DA RECONSIDERATION AMENDMENT - OCTOBER 2025

PROJECT
17-21 UNIVERSITY AVENUE & 24 MARCUS CLARKE STREET,
CANBERRA, ACT

DRAWING TITLE
SOLAR ACCESS 3D ANALYSIS NORTHERN CORNER 1PM,
2PM, 3PM

DRAWING NUMBER
ADA.06.08

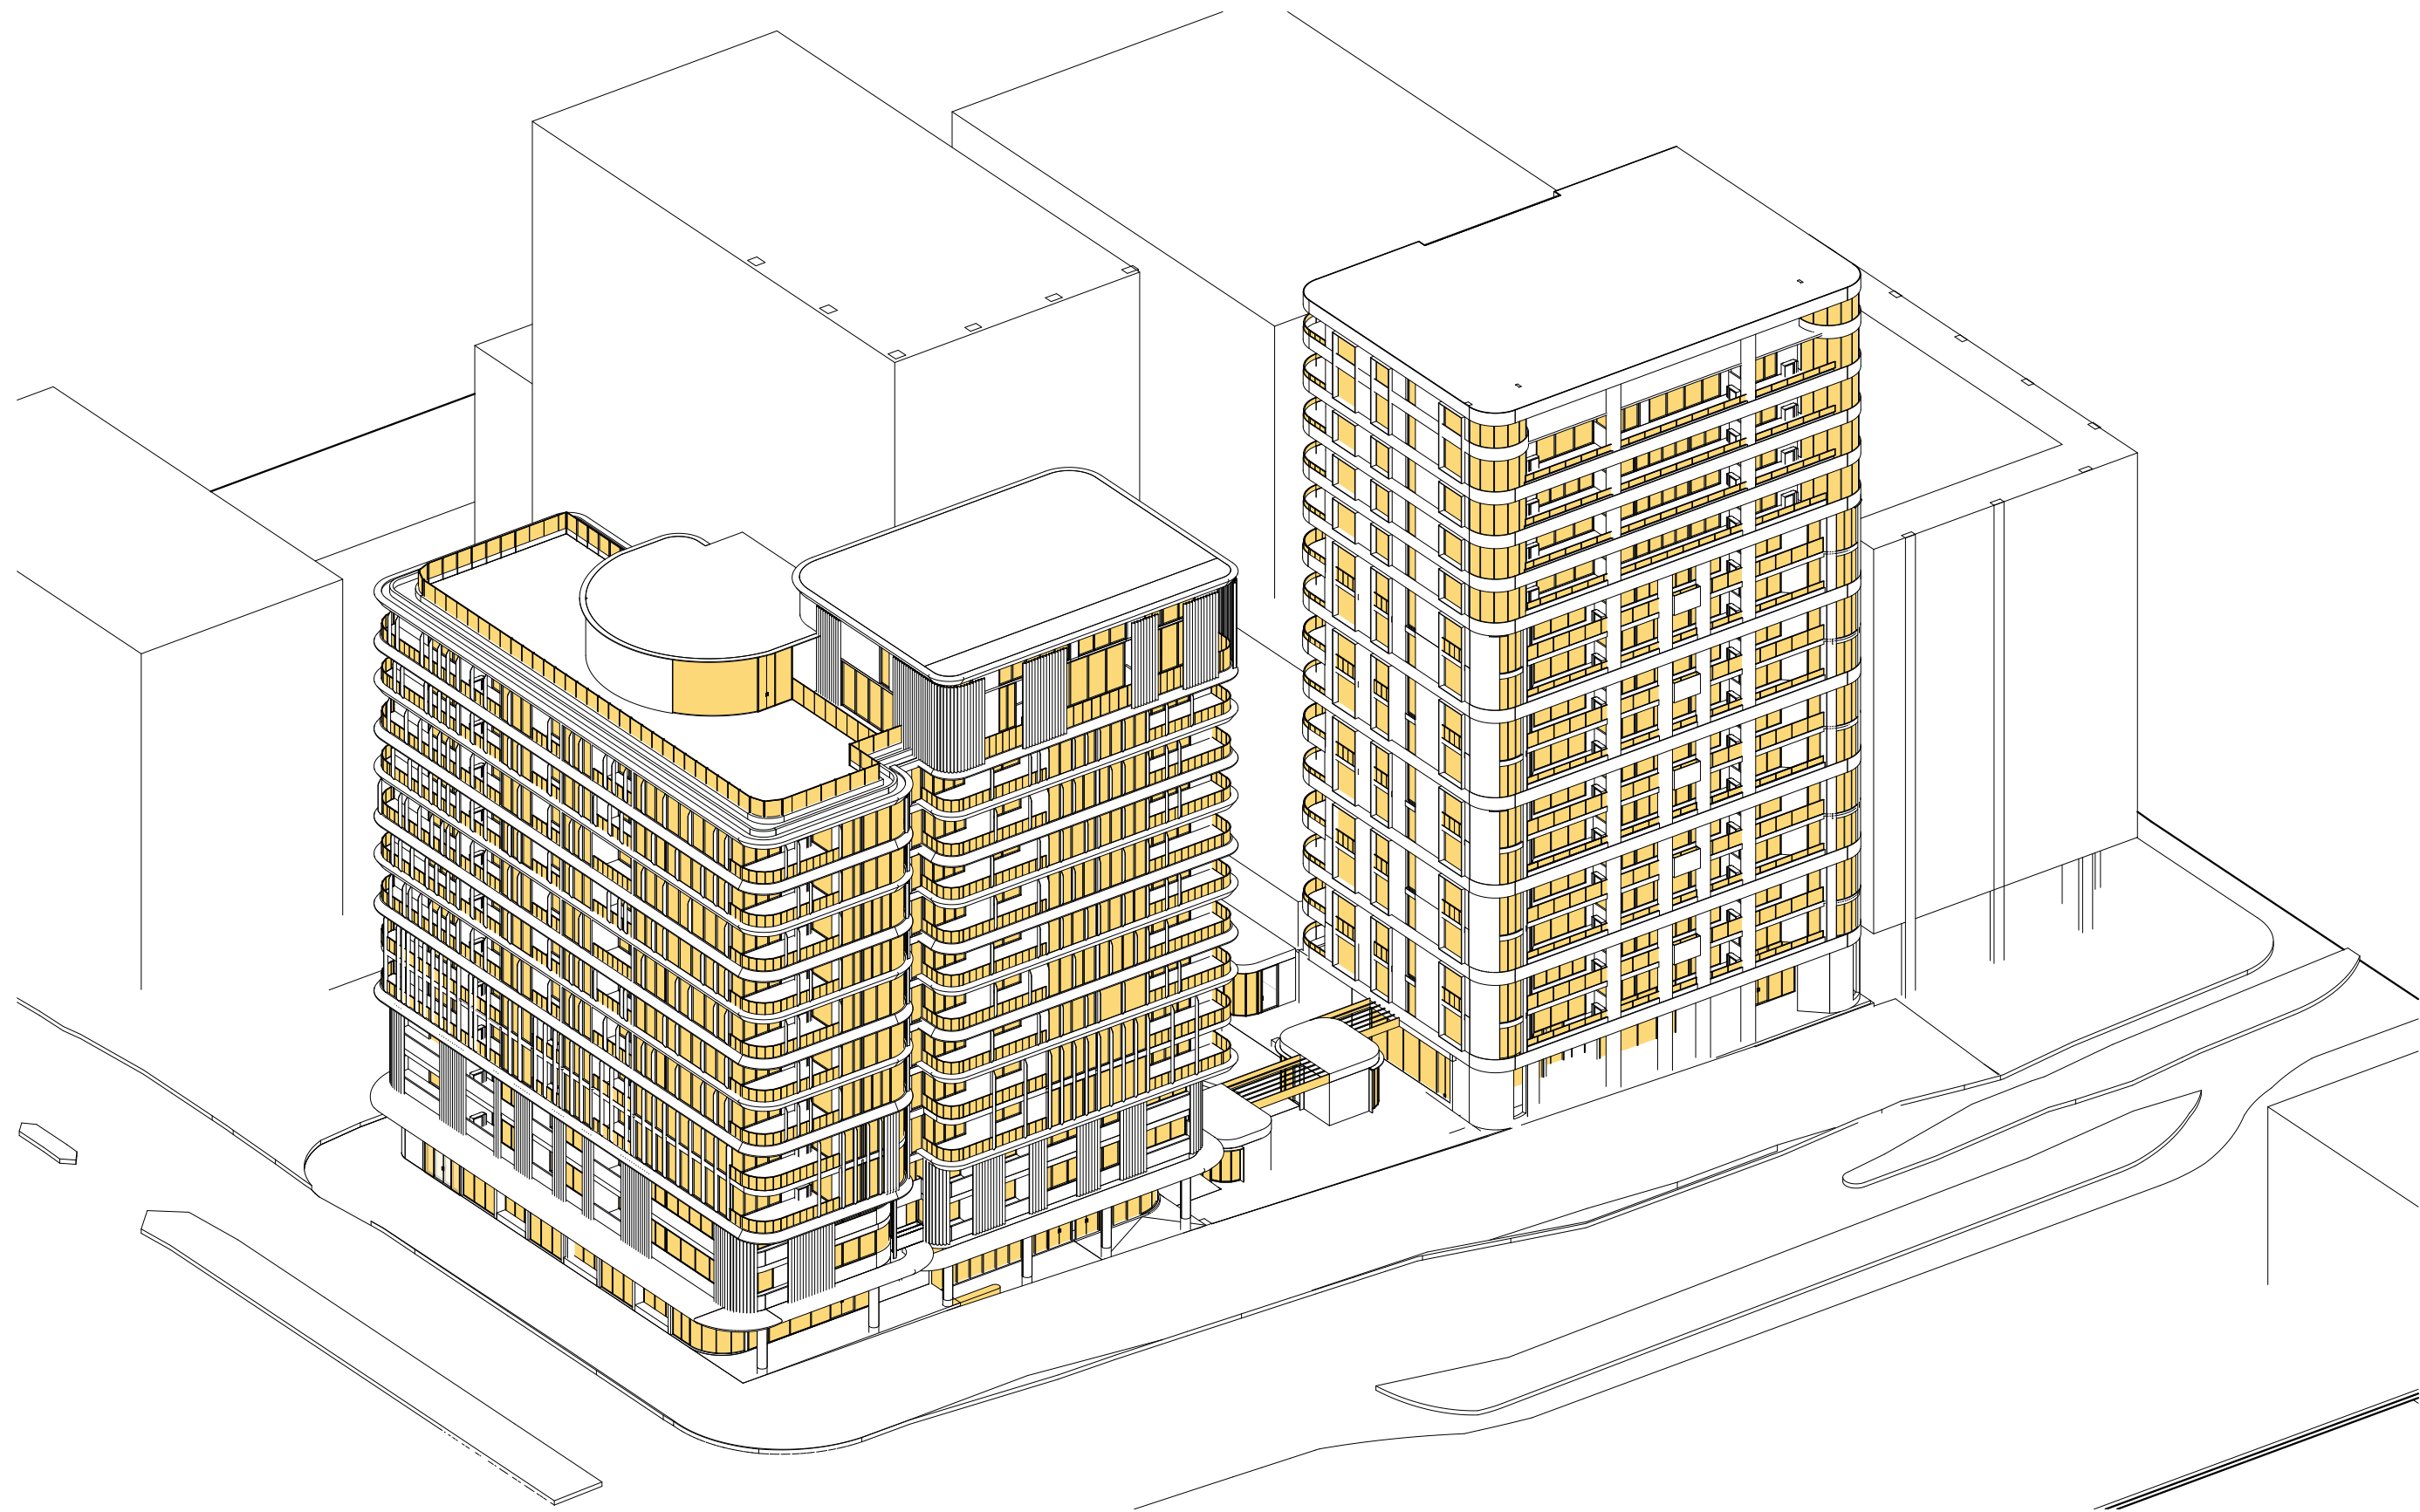
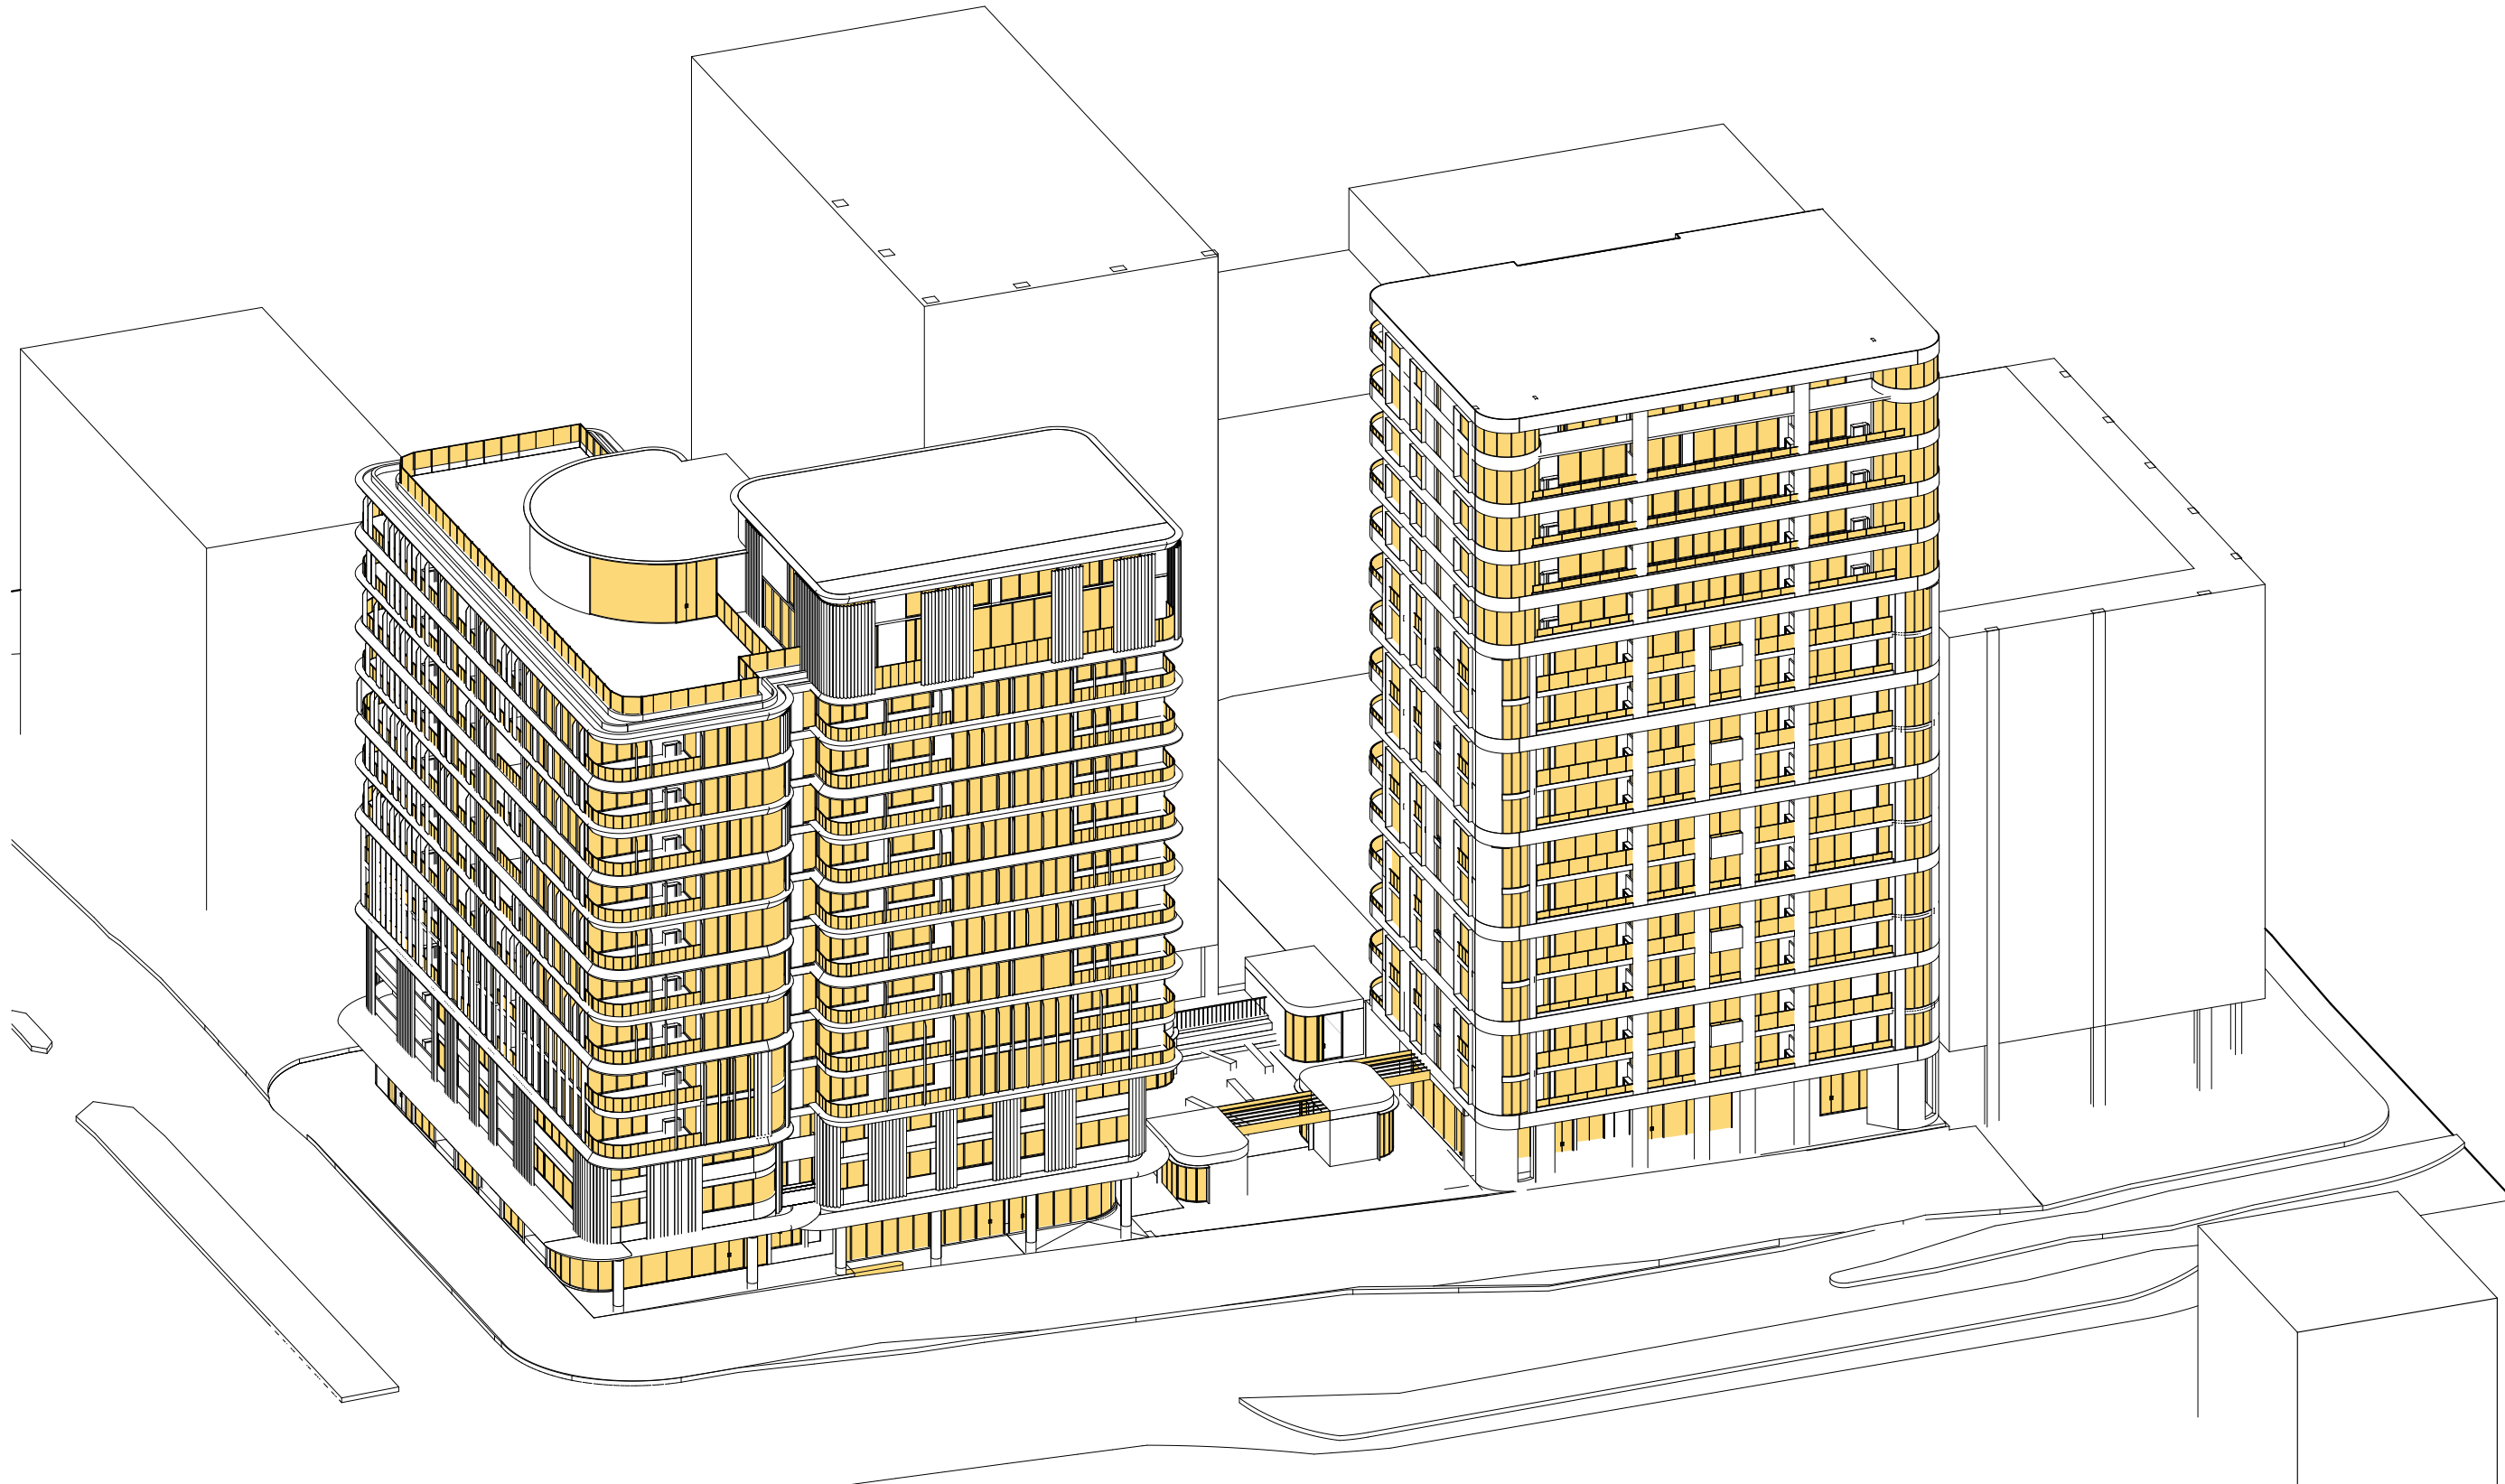
01. UPPER LEVEL CHANGES
- OVERALL HEIGHT OF BUILDING A REDUCED AND BUILDING B INCREASED TO ALIGN WITH AUTHORITY DISCUSSIONS
 - COMMON ROOFTOP GARDEN ADDED TO BUILDING A ADDRESSING UNIVERSITY AVENUE
 - BUILDING FACADES DESIGN IMPROVEMENTS
 - UNIT PLANS UPDATED AND UNIT MIX AMENDED
 - RECONFIGURATION OF BUILDING CORE THROUGHOUT THE UPPER LEVELS
 - WINTER GARDENS REMOVED AND REPLACED WITH DEDICATED BALCONY SPACES
 - UPPER LEVEL ENCROACHMENTS CONTAINING GFA REMOVED FROM UNIVERSITY AVENUE FRONTAGE
 - SOLAR ACCESS TO UNITS MAXIMISED AND DEMONSTRATED

02. GROUND FLOOR CHANGES
- AWNING ADDED TO UNIVERSITY AVENUE
 - GROUND FLOOR COMMERCIAL LEVELS ADJUSTED TO EXISTING VERGE LEVELS AND REDUCE STAIRS
 - LEVELS ADJUSTED IN THE CENTRAL LANDSCAPE SPACE FOR ACCESSIBILITY
 - SERVICE LOCATIONS UPDATED TO SUIT SERVICE LOCATIONS
 - INCREASE TO LANDSCAPE AREAS
 - UPDATE TO WASTE ROOMS WASTE COLLECTION STRATEGY
 - ON GRADE PARKING ALONG DARWIN REMOVED AND RELOCATED TO THE UPPER BASEMENT LEVEL
